Subject: Devil's Gate Sediment Removal Project

To: Bill Bogaard, Mayor
From: John J. Kennedy
Date: 2 November 2014
Subject: Devil's Gate Sediment EIR

Final EIR Review – The Big Dig

Figure 8-27 Graph of Historical Sediment Storage at Devil's Gate Reservoir

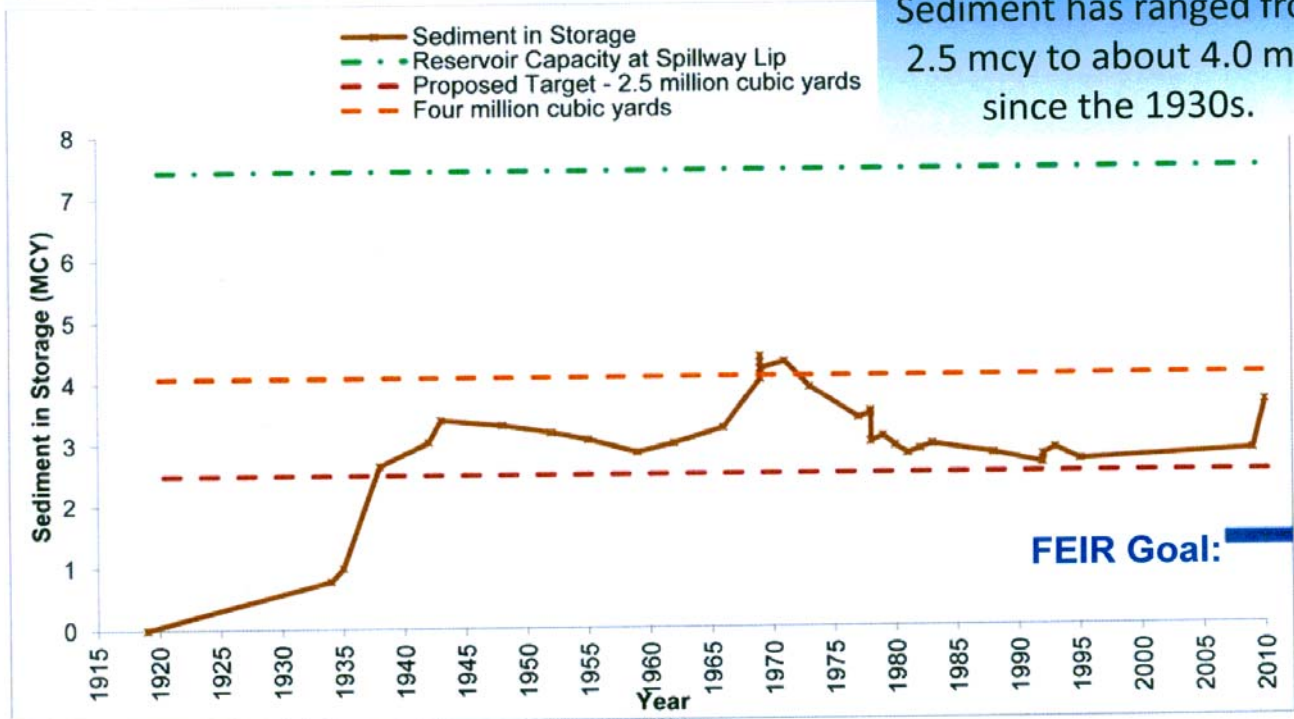
If the County's goal is so sacred, why hasn't the sediment level been that low since 1935?

Footprint of the FEIR Compared to the Pasadena Recommended Footprint

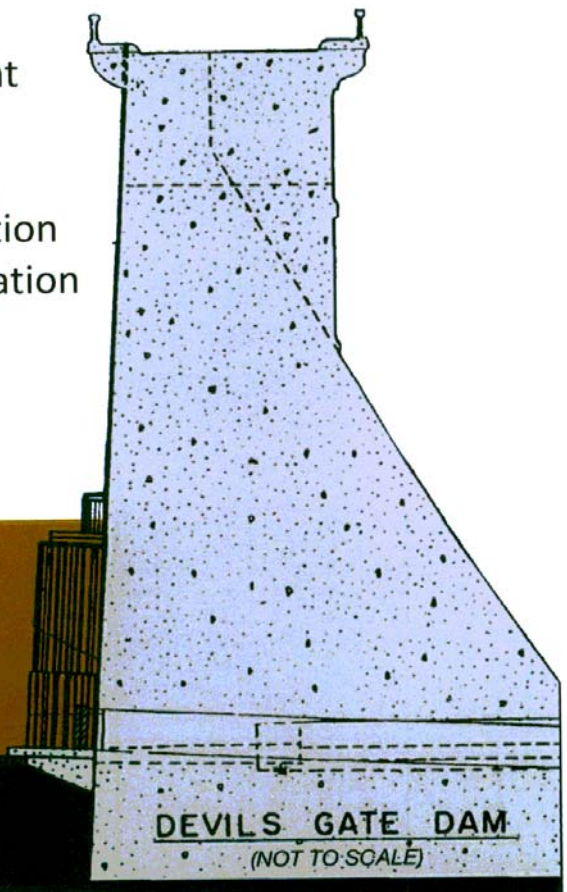
* Pasadena footprint of forty acres includes ten acre seasonal conservation pool near dam.
